ORDINANCE NO. L-2016-5
VILLAGE OF SHOREWOOD HILLS
DANE COUNTY, WISCONSIN

AN ORDINANCE CHANGING THE ZONING CLASSIFICATION OF PROPERTY
LOCATED AT 2801-2725 MARSHALL COURT
FROM C-3 MEDICAL OFFICE-COMMERCIAL DISTRICT
TO A PLANNED UNIT DEVELOPMENT (PUD) DISTRICT

Re: Review of the proposed rezoning of 2725-2801 Marshall Court: "Arbor Crossing II"
From: Medical Office-Commercial (C-3)
To: Planned Unit Development (PUD) / General Development Plan (GDP)

Figure 7 Parking Zones

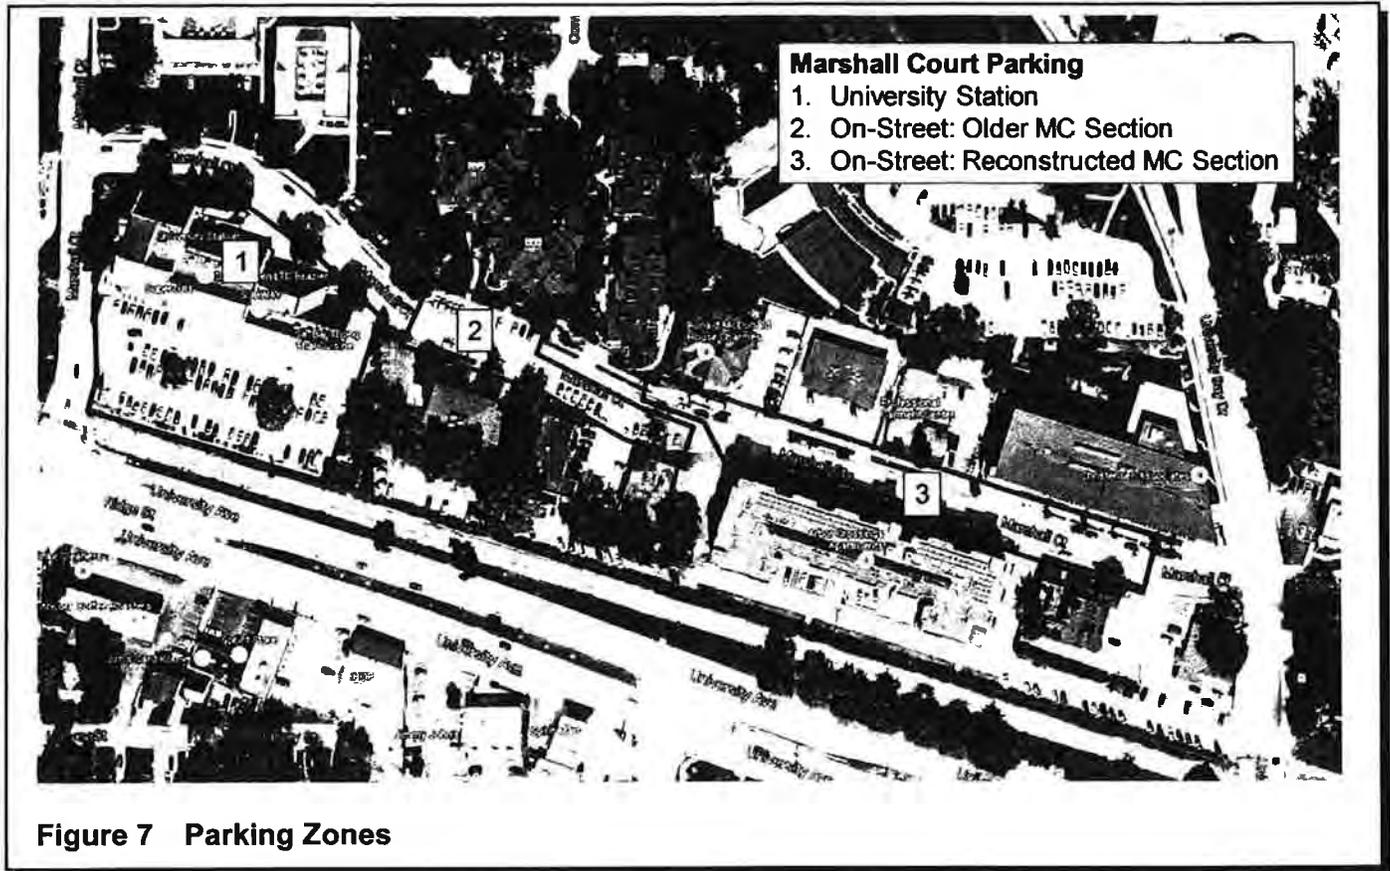
Strand staff and the Village of Shorewood Hills Police Department (SHPD) recorded parking stall occupancy at various times of the day between January 13 and January 22, 2016. Parking serving the University Station shopping center and on-street parking along Marshall Court was included. The parking was divided into three zones to better understand demand at various locations along the street. The zones are shown in Figure 7. A summary of the results is provided in Figure 8.
